gProjects Y13

townhomes at 2707-2711 east yesler way

section 3.0 development objectives

section 8.0 response to edg

3025438 PARCEL Z

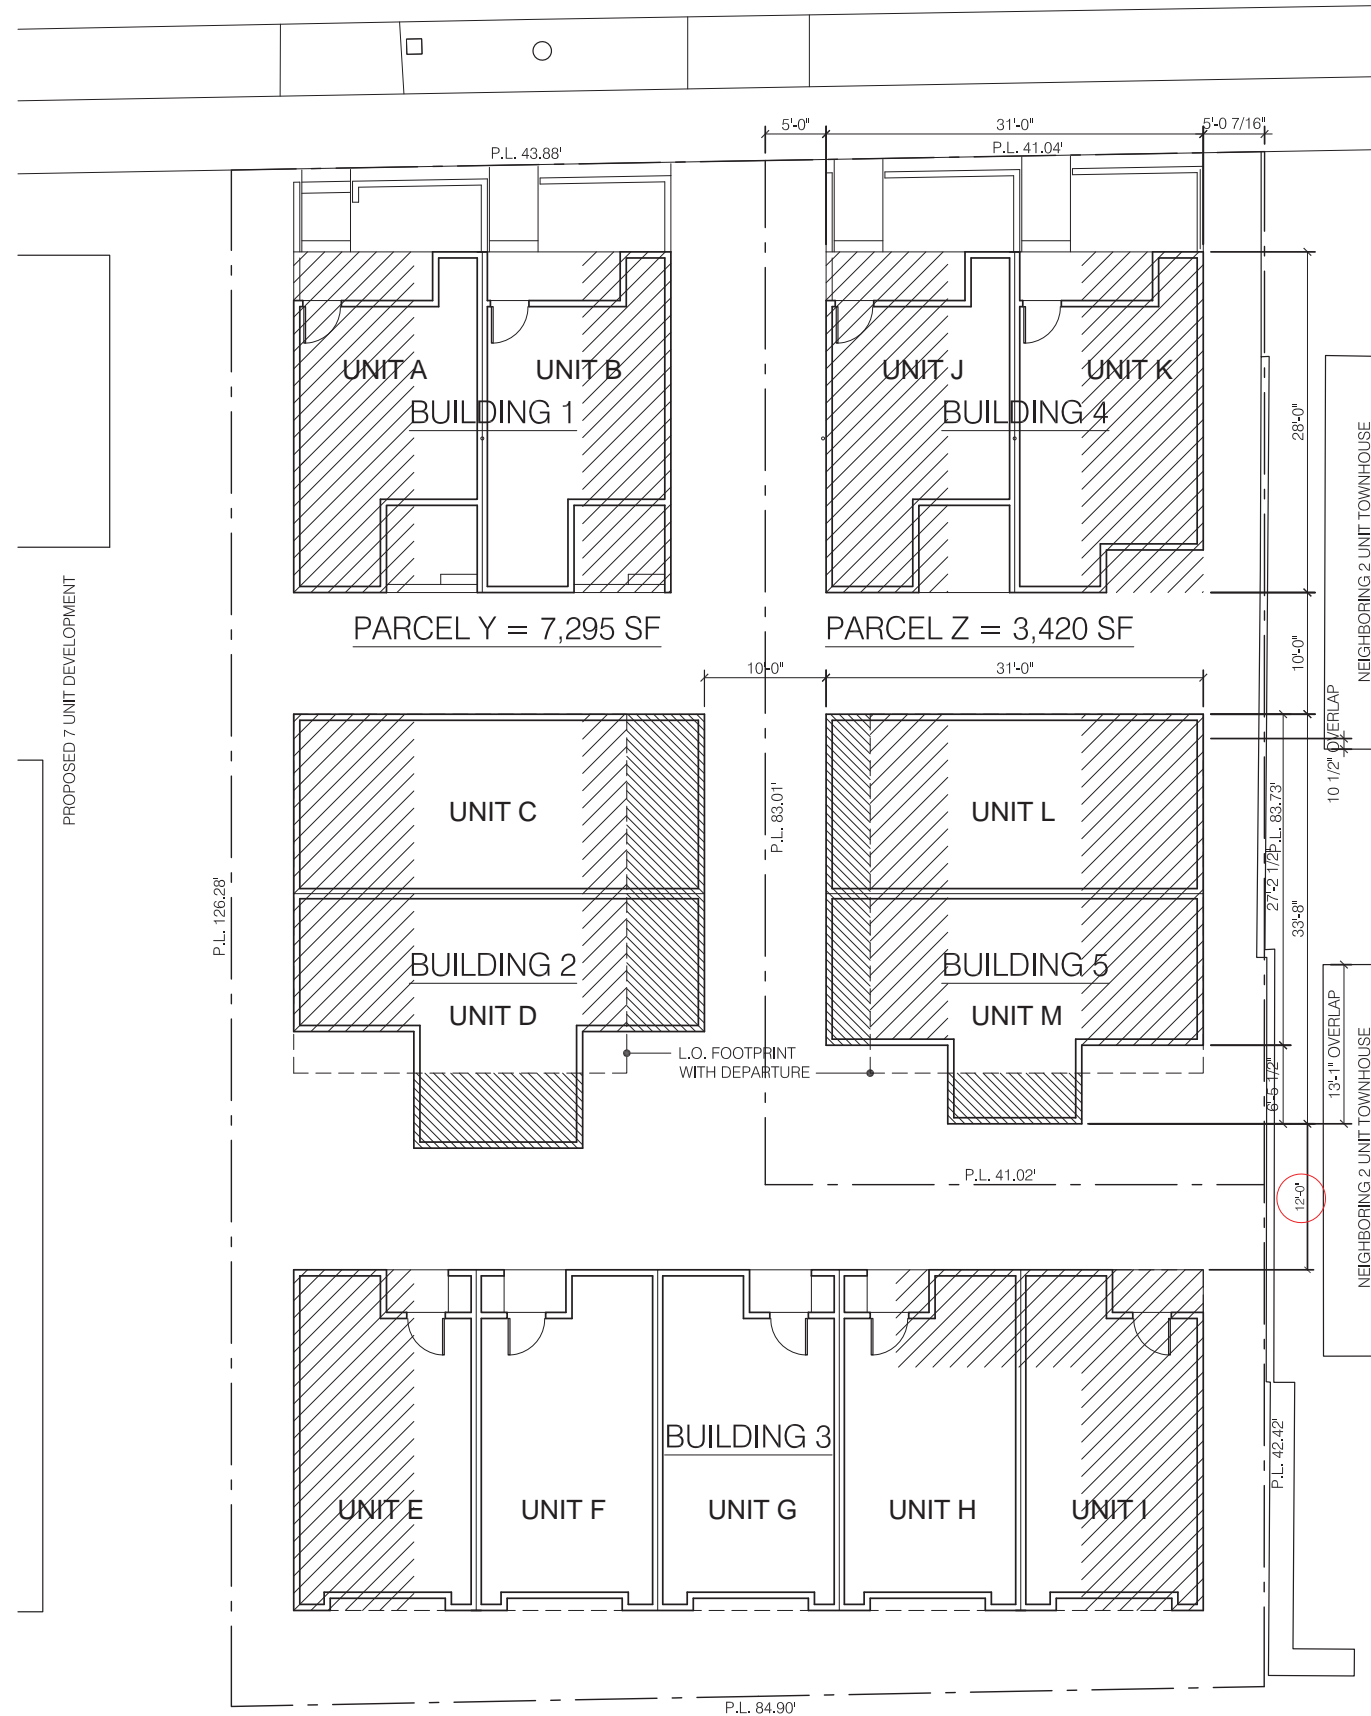
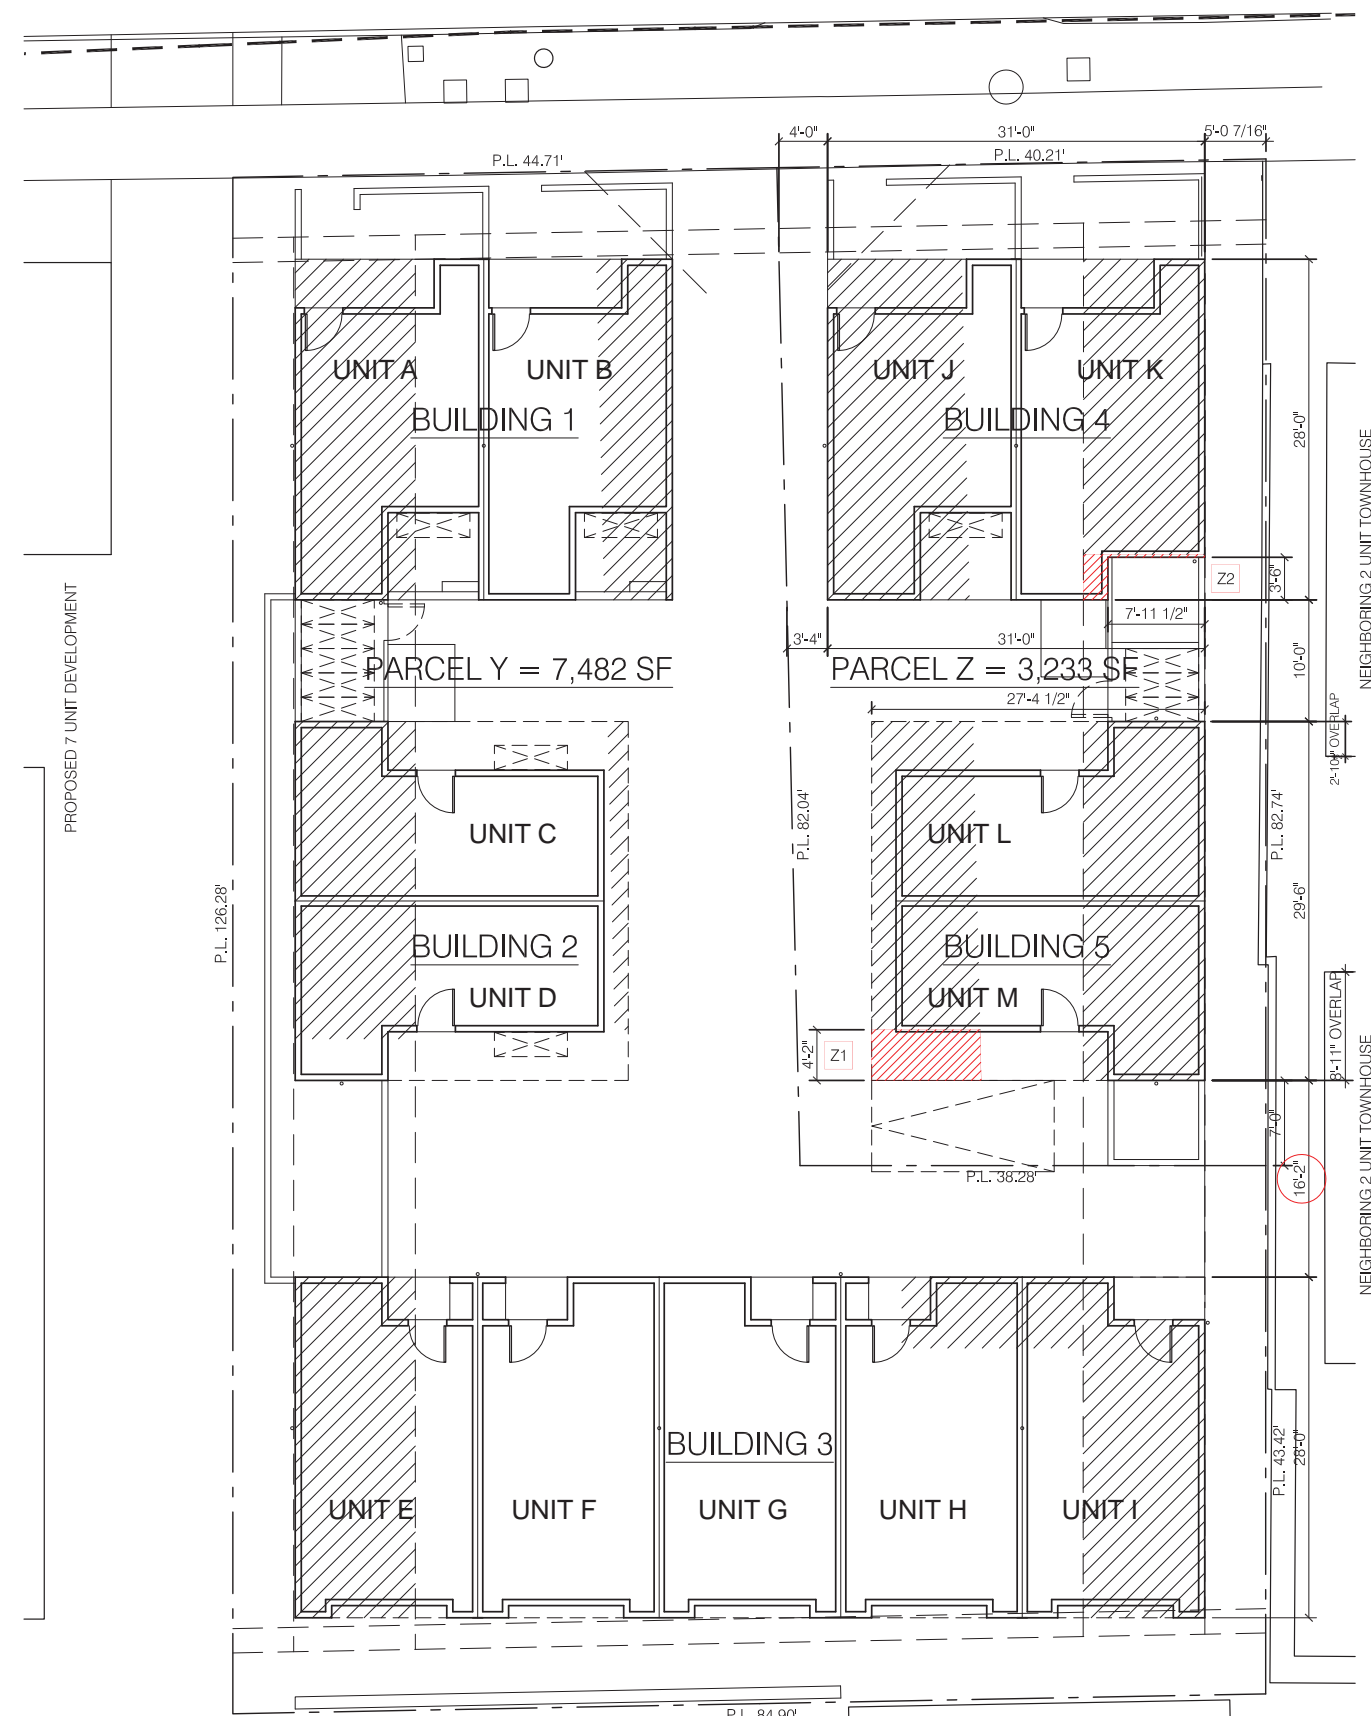
1. The project requests (2) two departures for minimum setbacks at Parcel Z.

Departure requested to allow a 3'-4" minimum side setback at Bldg 4 and a 5'-0" average rear setback at Bldg 5

Z1. Parcel Z west facade Bldg 4-5 = $82.04' \times 0.65 = 53.33'$

Z2. Parcel Z east facade Bldg 4-5 = $82.74' \times 0.65 = 53.78'$

Justification: Z1 is a result of an interior line created through the LBA. As a single project this facade is conforming or greater than the requirements of 23.45.518.f. separation between multiple structures (see proposed plan, page 43).

A conforming and functional floor plan would require Bldg 5 to step at the facade length limit, then project to minimum interior separation distance once the facade is greater than fifteen feet from the lot lines. This will create reduced building separations across the project, diminish the quality of open space, create functional layout issues within units, and reduce the width of view corridors for the neighboring properties through the proposed project's open spaces. This is particularly apparent with the neighboring townhome to the southeast (see east elevation window & door areas).
